USNRC APPLICATION
SUA-1341 License Amendment
Ludeman Project
Converse County, WY

June 2013

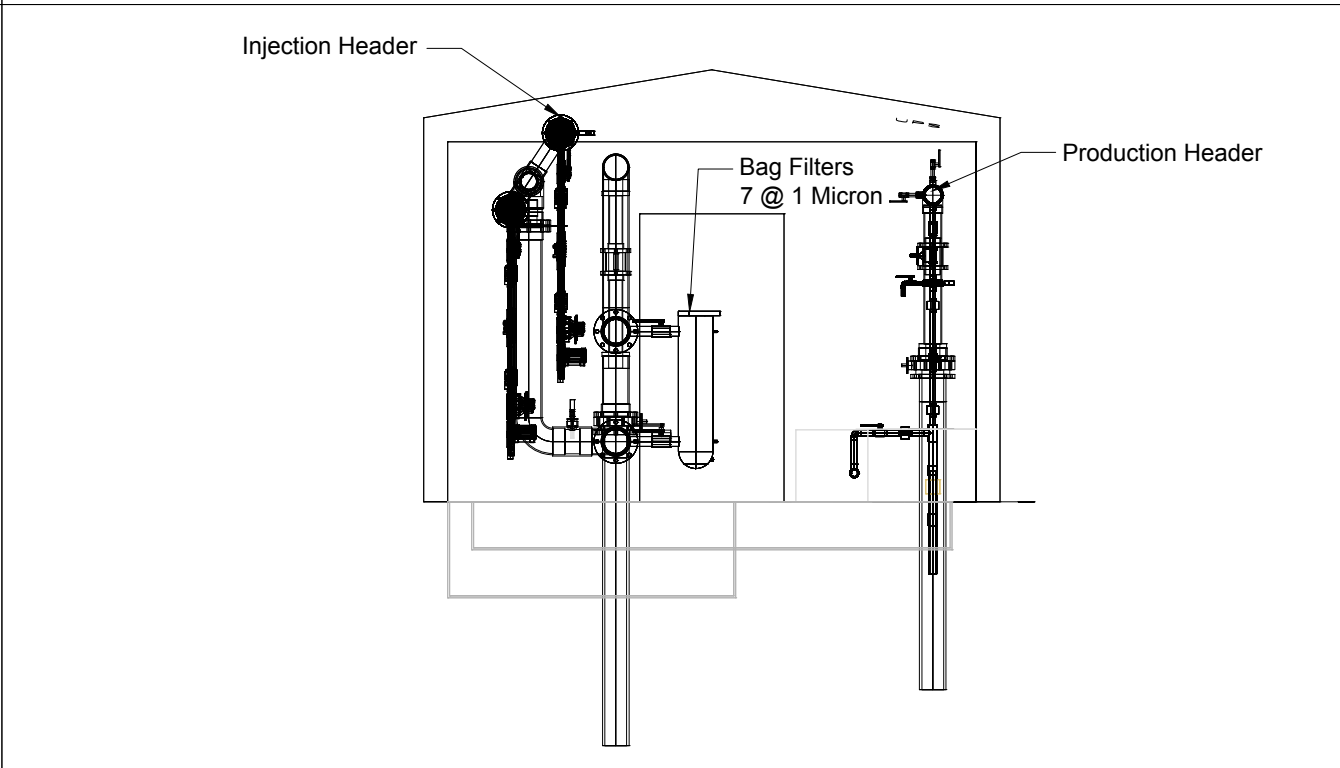
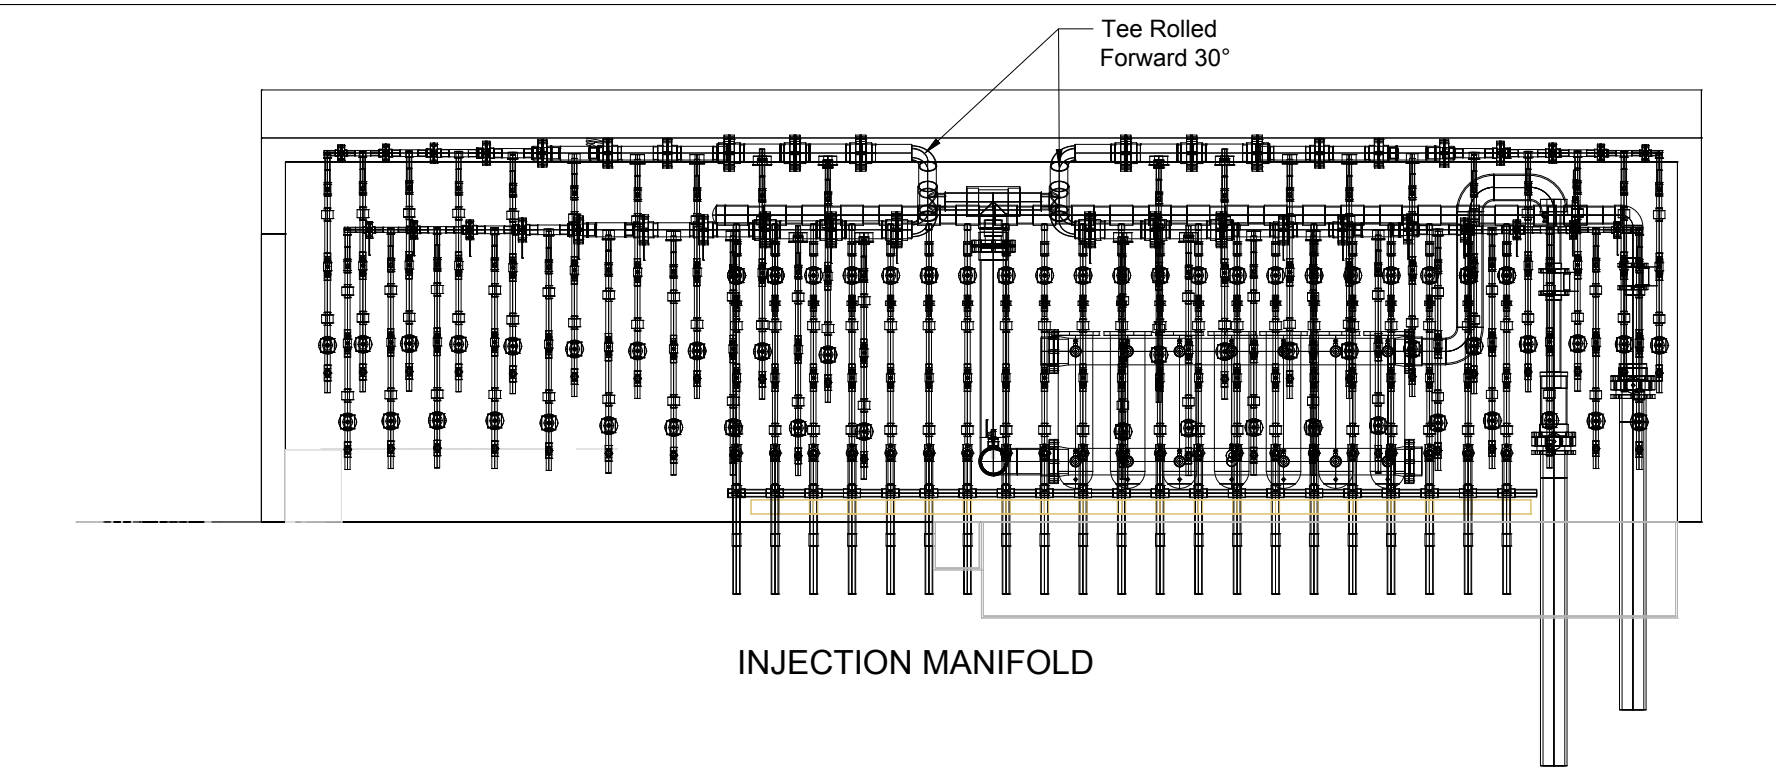
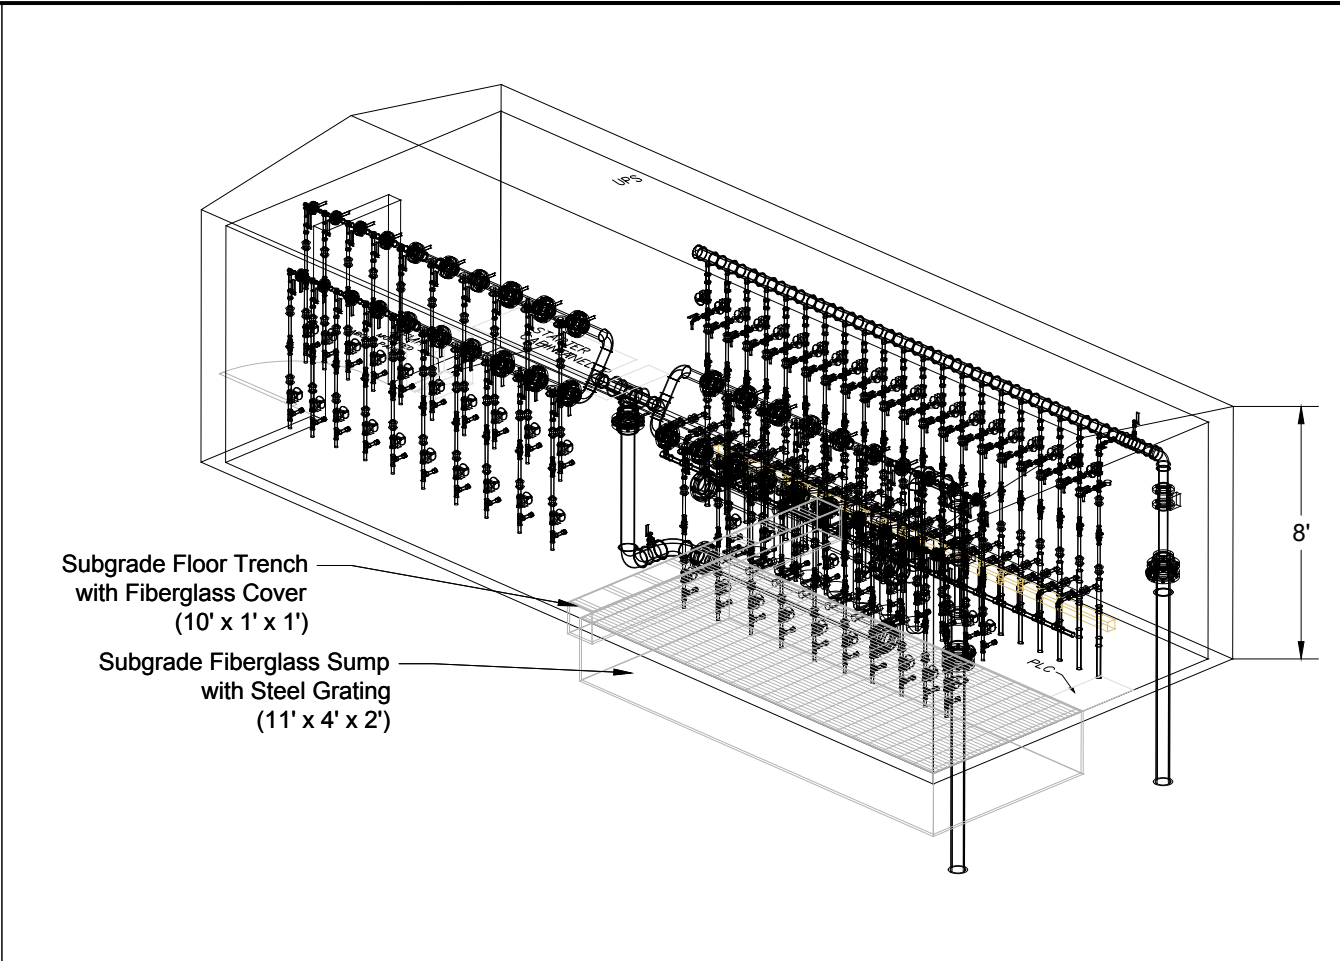
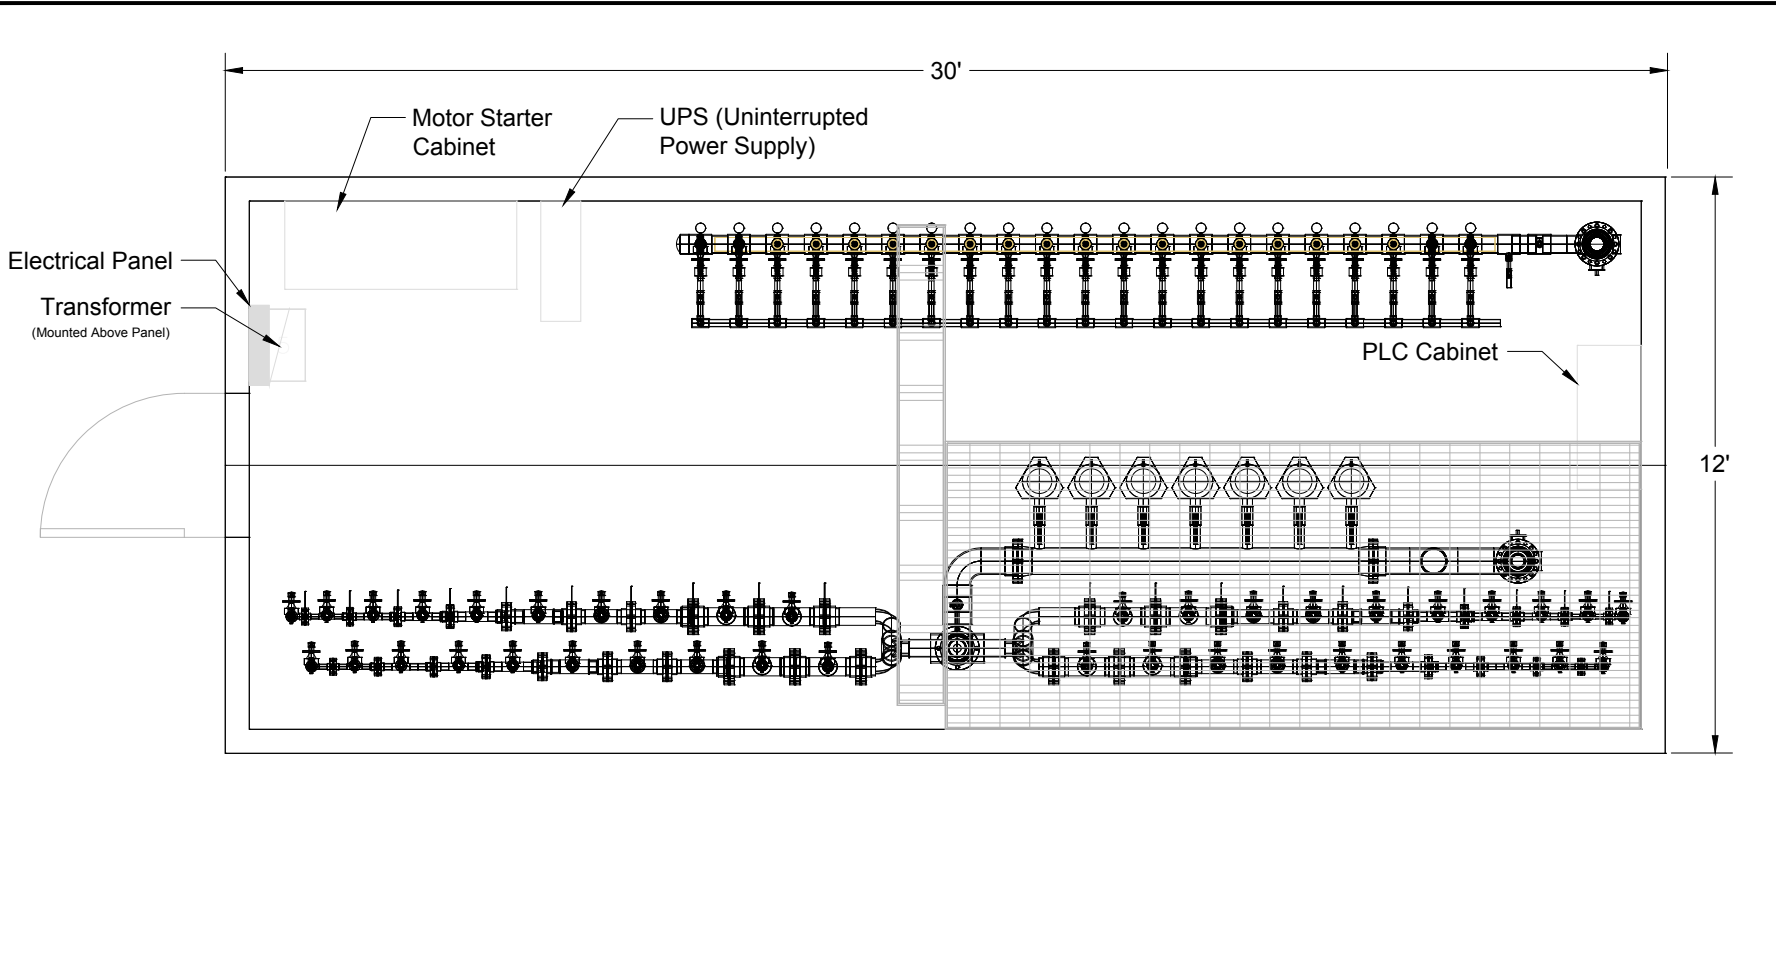
Uranium One should provide a schematic of the header house design.

The schematic of the typical header house design shown below has been added to TR Section 3:
